# 1992 Corvette: Service Bulletin: Harsh 1-2 Upshift

**Subject:** HARSH 1-2 UPSHIFT INSTALL SERVICE PACKAGE

**Bulletin Number:** 92-318-7A - (09/15/1992)

TRANSMISSION APPLICATIONS: SUBJECT: 1992 HYDRA-MATIC 4L60 Harsh 1-2 Upshift ;Install Service Package

Figure 1 - HYDRA-MATIC 4L60 Transmission Identification Information

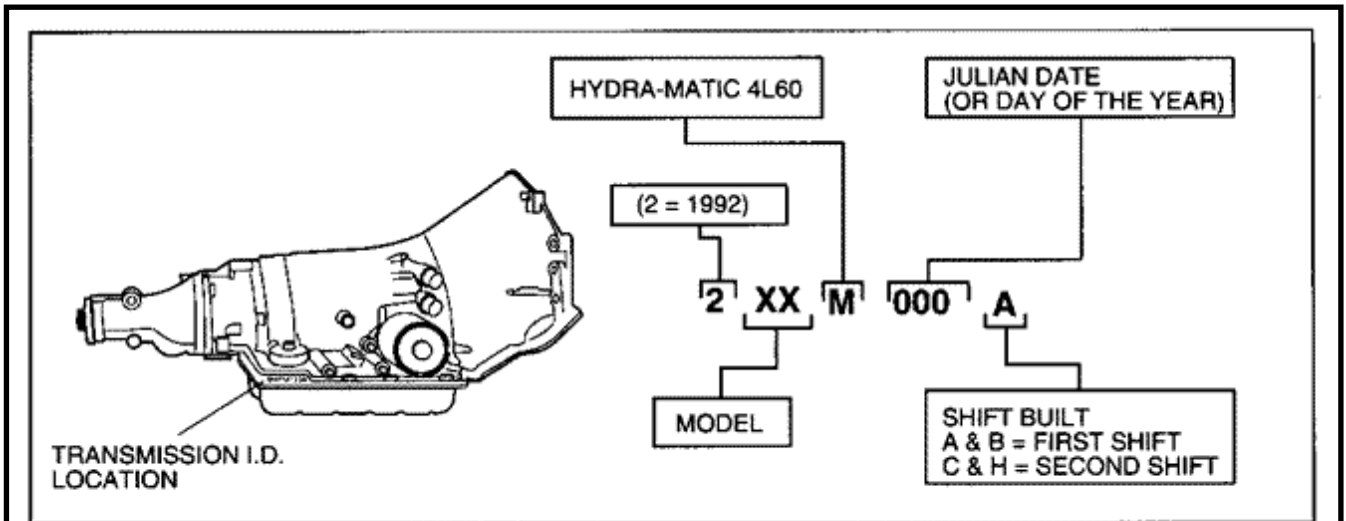
Some vehicles equipped with a 1992 HYDRA-MATIC 4L60 transmission built between Julian Date 061 (March 1, 1992) and Julian Date 171 (June 19, 1992) may experience a harsh 1-2 upshift. NOTE: Once the transmission is brought to operating temperature, the condition may not be able to be reproduced until a "cold soak" (overnight) is performed.

Figure 2

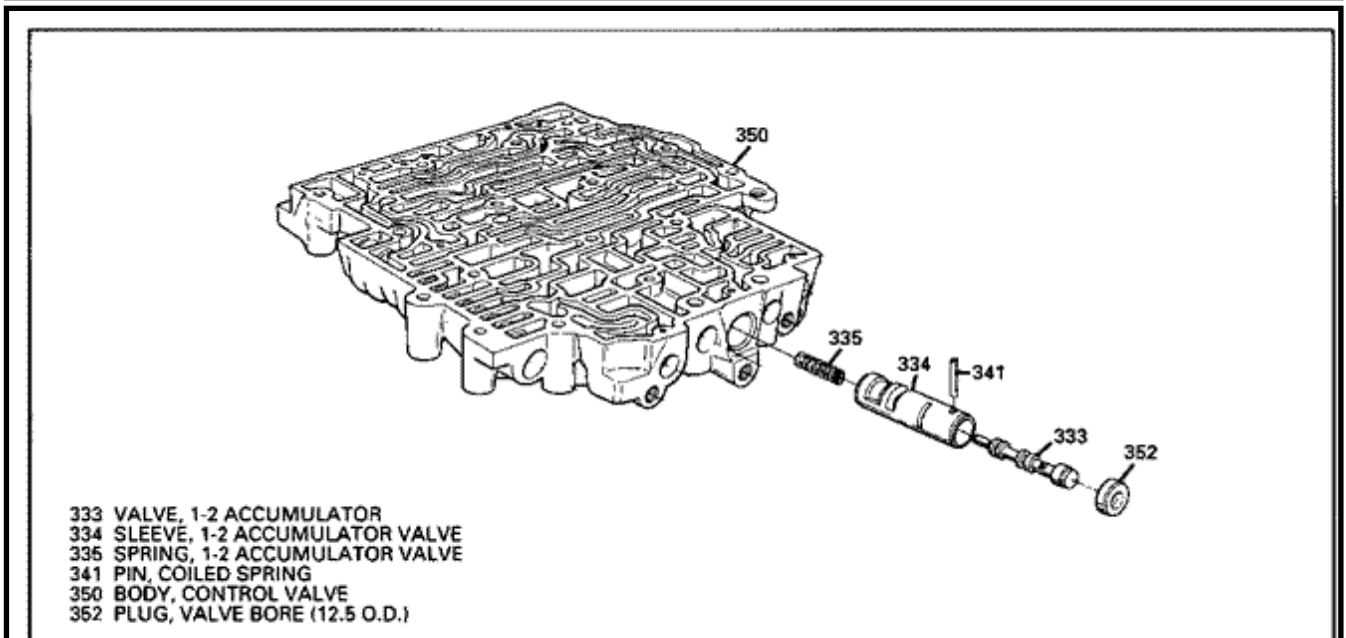
The above condition may be caused due to a tapered 1-2 accumulator sleeve. The tapered bore may cause the 1-2 accumulator valve to stick in the bottom of the bore.

To improve the 1-2 shift, install the service package listed in this bulletin. A 1-2 accumulator valve and 1-2 accumulator valve sleeve (which, normally, is not serviceable) is included in the package.
